PLANNING AND ZONING AND COUNTY COUNCIL INFORMATION SHEET
Planning Commission Public Hearing Date February 18th, 2020.

Application:	CU 2206 Linder & Company Inc. (Evans Farm)
Applicant:	Linder & Company, Inc. (Attention: Andrea Finerosky) 234 North James Street Newport, DE 19804
Owner:	Linder & Company, Inc. 234 North James Street Newport, DE 19804
Site Location:	Lying on the north corner of the intersection of Railway Road (S.C.R. 350) and Old Mill Road (S.C.R. 349) and also being on the south side of Railway Rd. (S.C.R. 350) approximately 696 feet northeast of Old Mill Rd. (S.C.R. 349), Ocean View, DE 19970.
Current Zoning:	General Residential (GR)
Proposed Use:	Multi-Family Residential (200 units)
Comprehensive Land Use Plan Reference:	Coastal Area
Councilmatic District:	Mr. Hudson
School District:	Indian River School District
Fire District:	Millville Fire District
Sewer:	Sussex County
Water:	Private, On-Site
Site Area:	50.62 acres +/-
Tax Map ID.:	134-12.00-74.00

To: Sussex County Planning Commission Members
From: Nicholas Torrance, Planner I
CC: Vince Robertson, Assistant County Attorney and applicant
Date: January 27th. 2021
RE: Staff Analysis for CU 2206 Linder & Company In

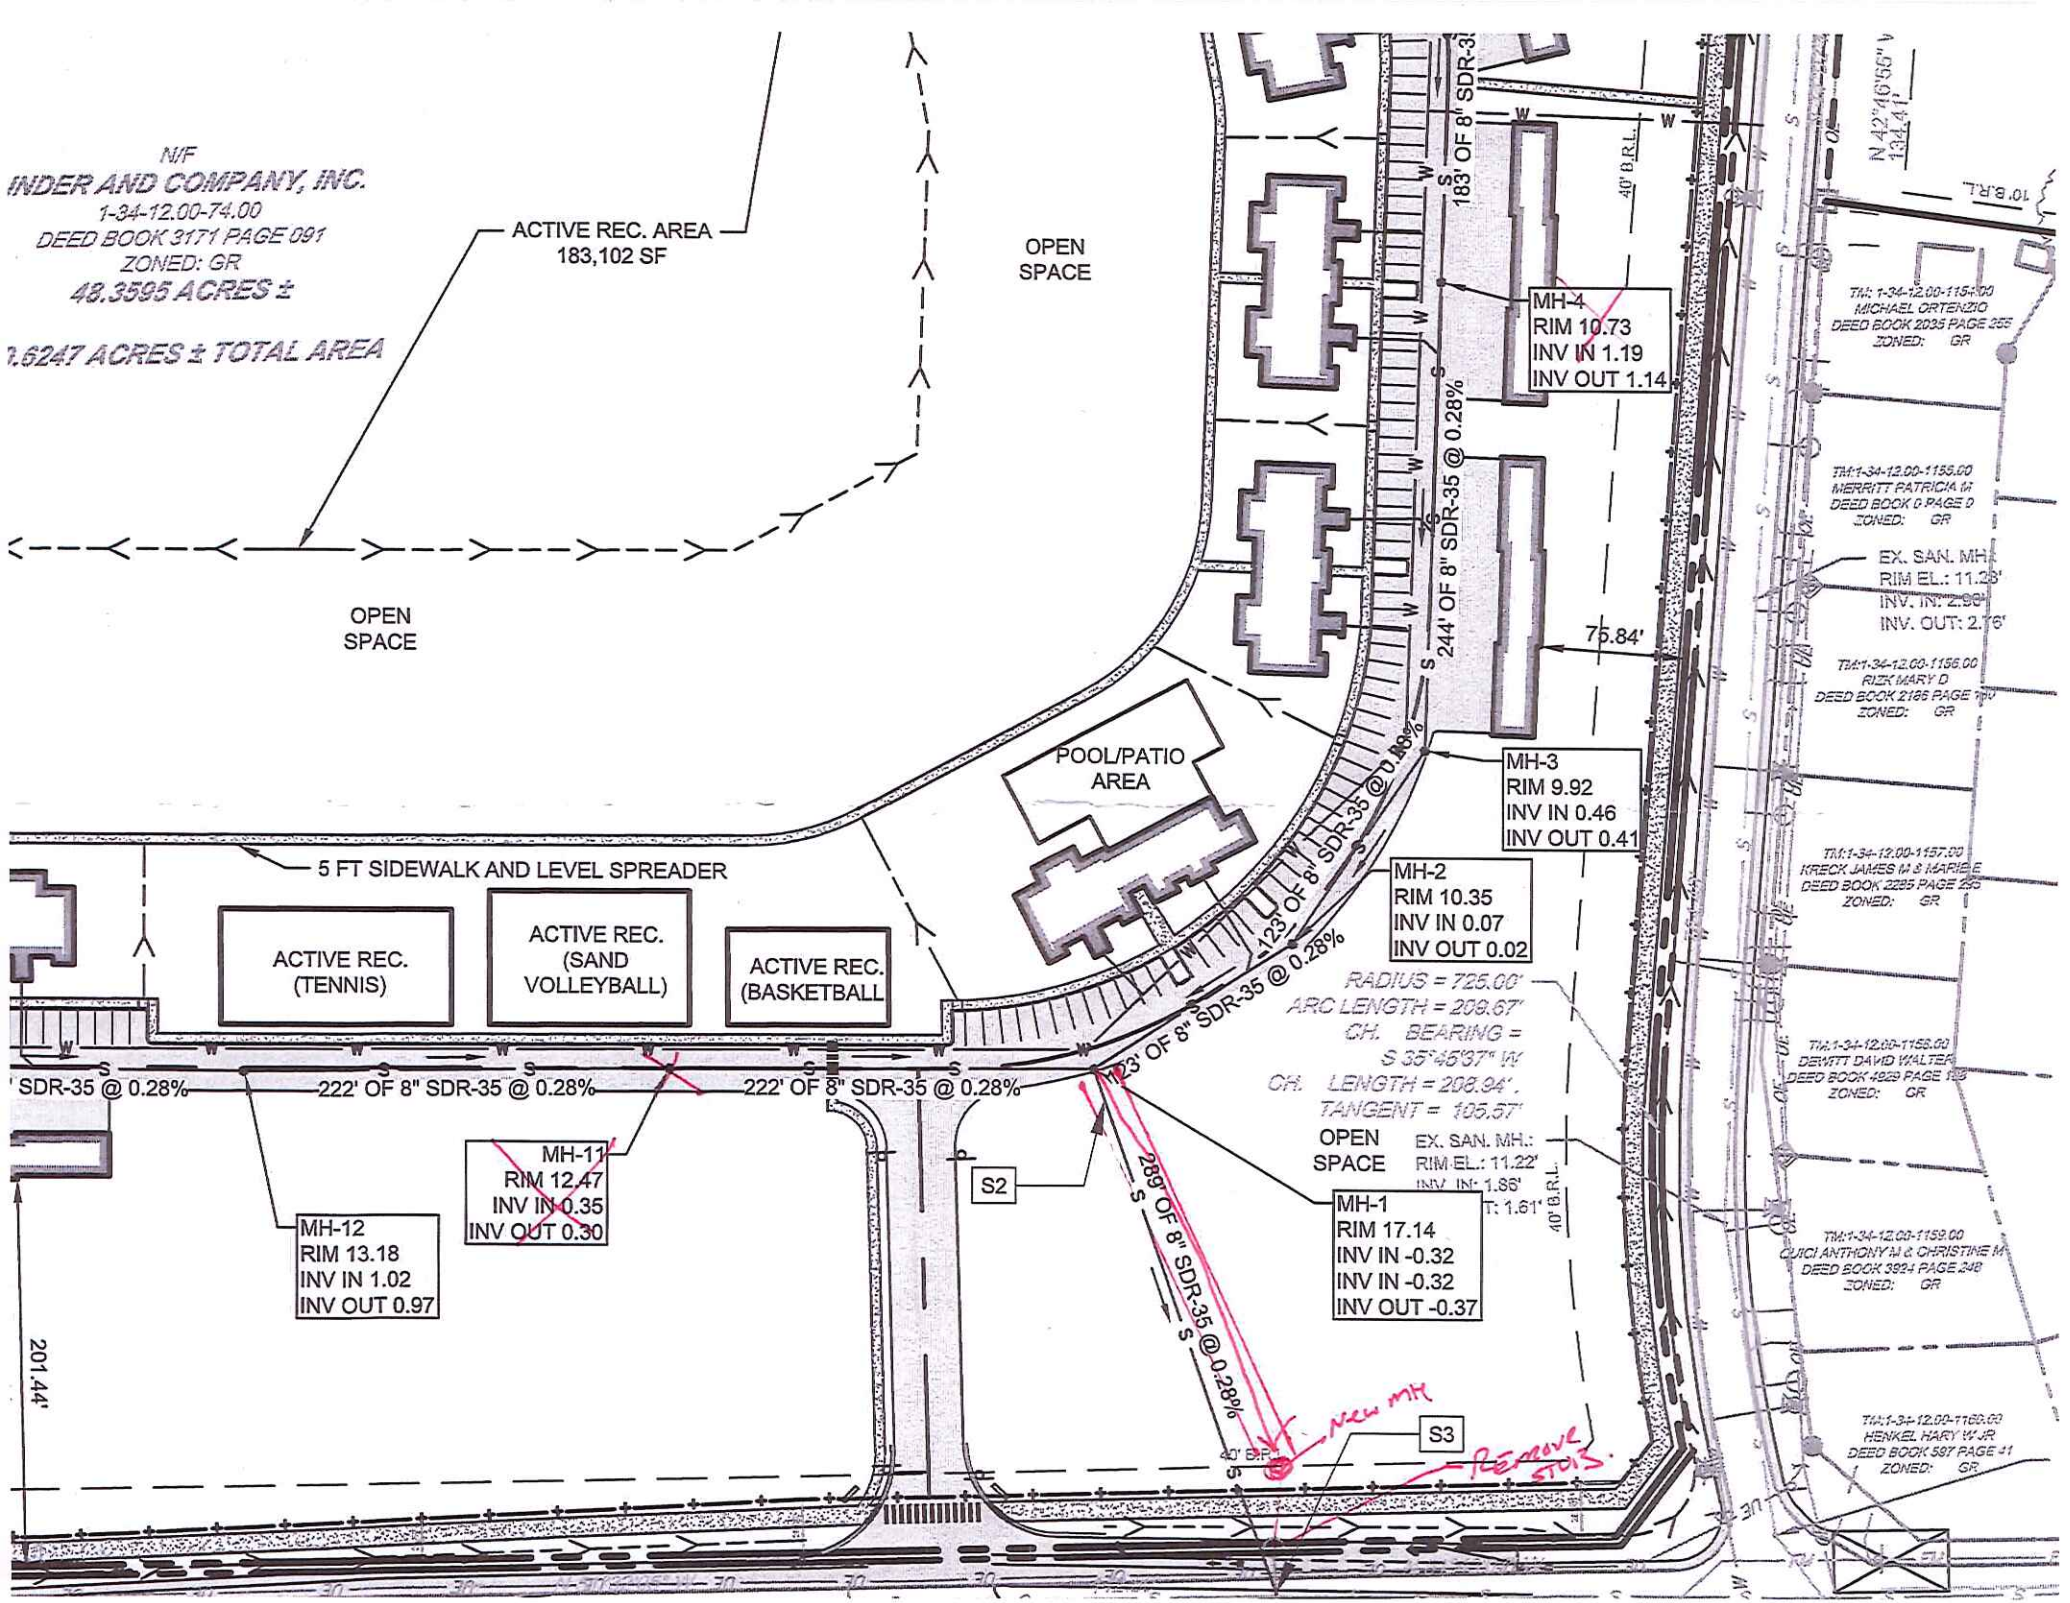
Additional Information: **Add new manhole as shown on SSCE plan. End run slope must be a minimum of .40%. Maximum run of 450' between manhole to reduce number of manholes necessary for the project. Change parcel number to 74.00 as shown on plan. Provide hard surface over pipeline from MH 1 to connection point.**

SHEET 3 OF 3

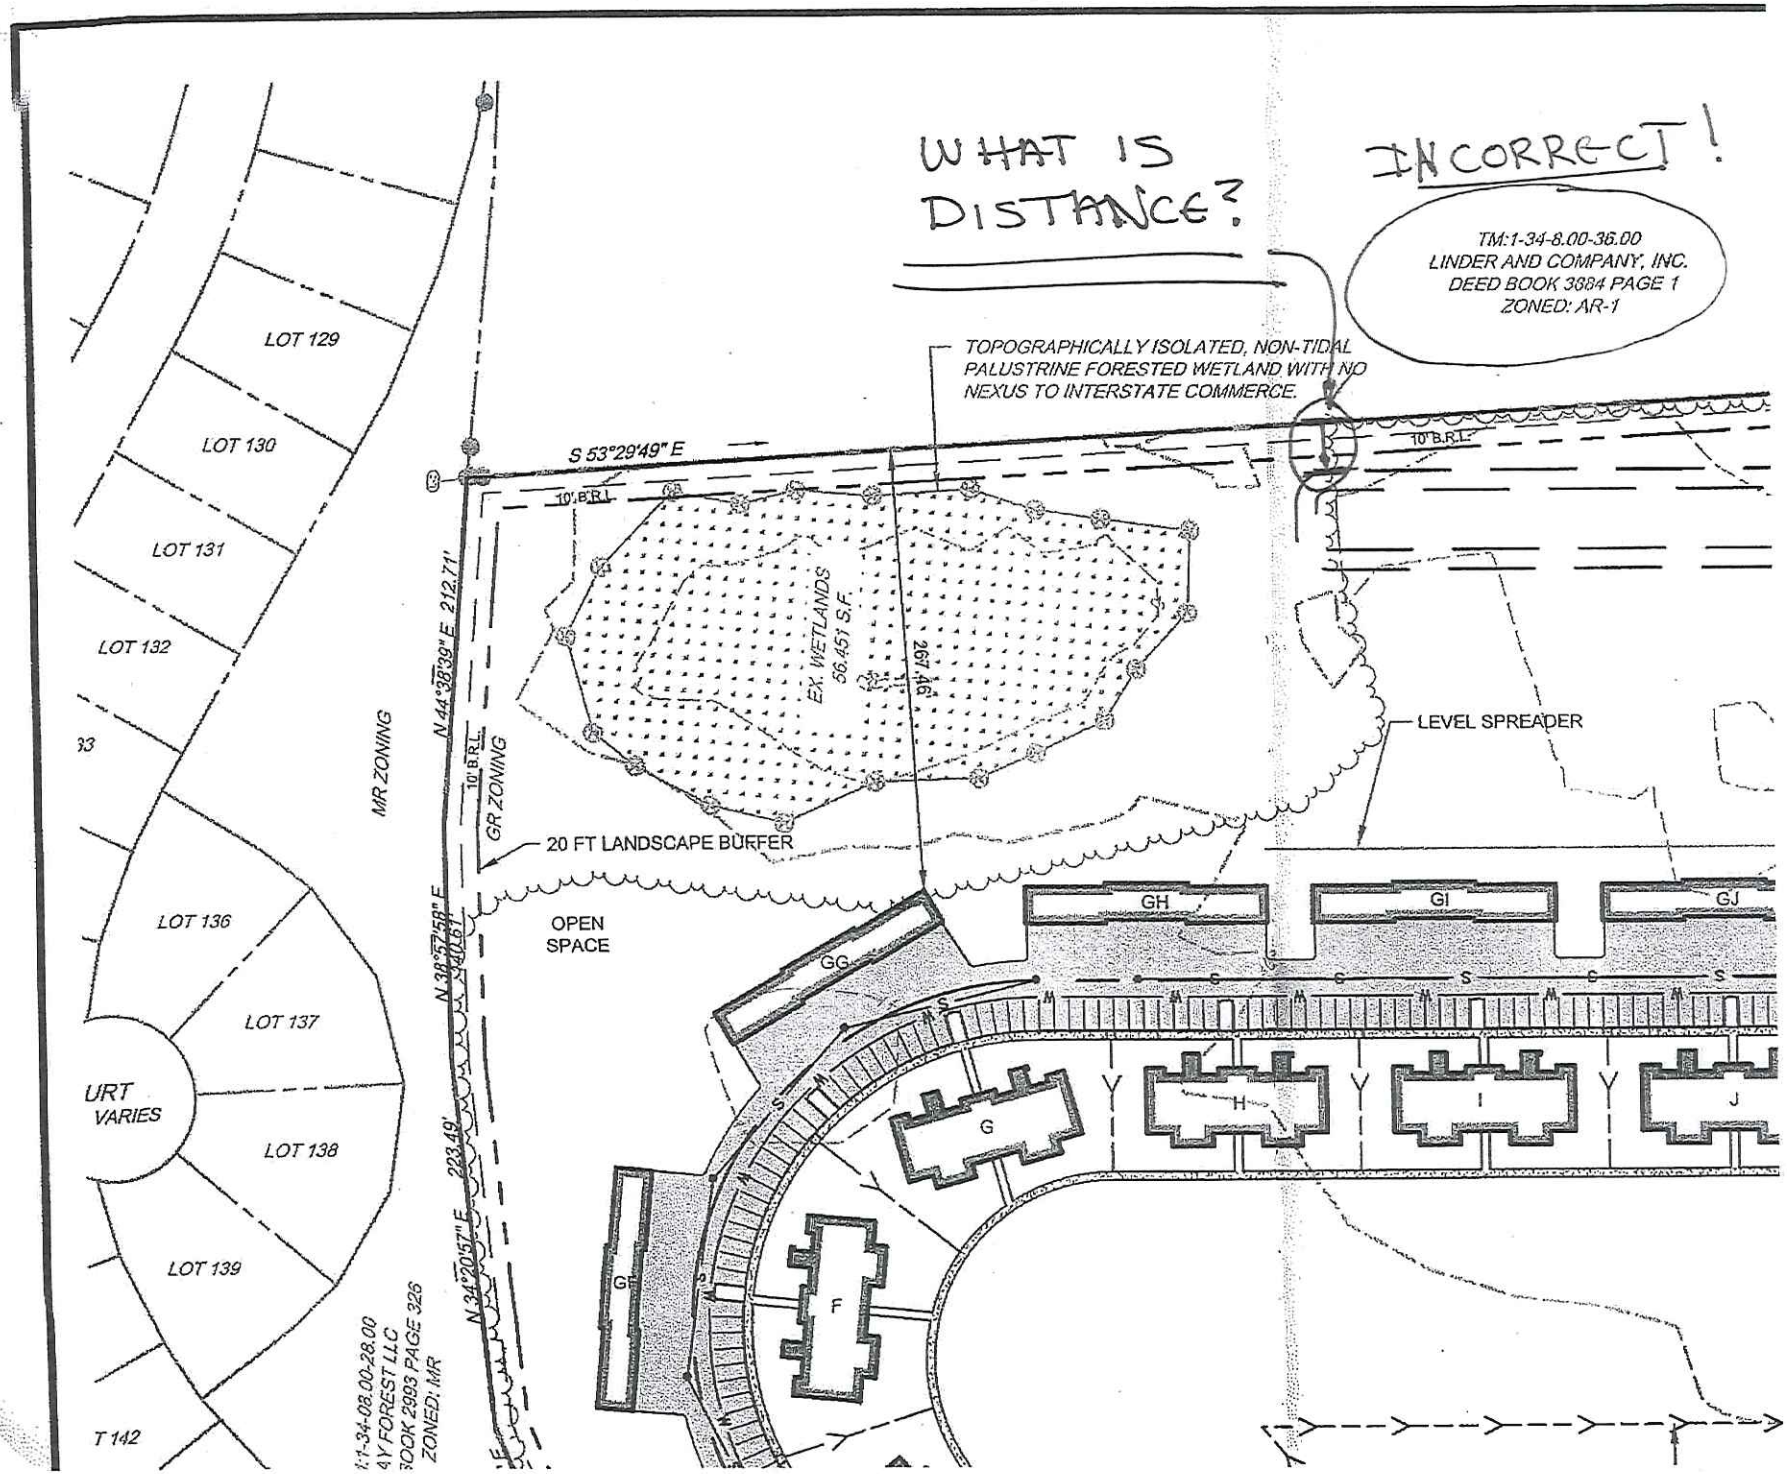
WHAT IS DISTANCE?
INCORRECT!
TM:1-34-8.00-36.00
LINDER AND COMPANY, INC.
DEED BOOK 3684 PAGE 1
ZONED: AR-1
TOPOGRAPHICALLY ISOLATED, NON-TIDAL PALUSTRINE FORESTED WETLAND WITH NO NEXUS TO INTERSTATE COMMERCE.
LOT 129
LOT 130
LOT 131
LOT 132
LOT 136
LOT 137
LOT 138
LOT 139
T 142
URT VARIES
MR ZONING
GR ZONING
S 53°29'49" E
N 44°38'39" E 212.71'
N 38°57'58" E 340.61'
N 34°20'57" E 223.49'
10' B.R.L.
EX. WETLANDS 56,451 S.F.
497.46'
20 FT LANDSCAPE BUFFER
OPEN SPACE
LEVEL SPREADER
GH
GI
GJ
GG
G
H
I
J
F
GF
1-34-08.00-28.00
Y FOREST LLC
OOK 2993 PAGE 326
ZONED: MR
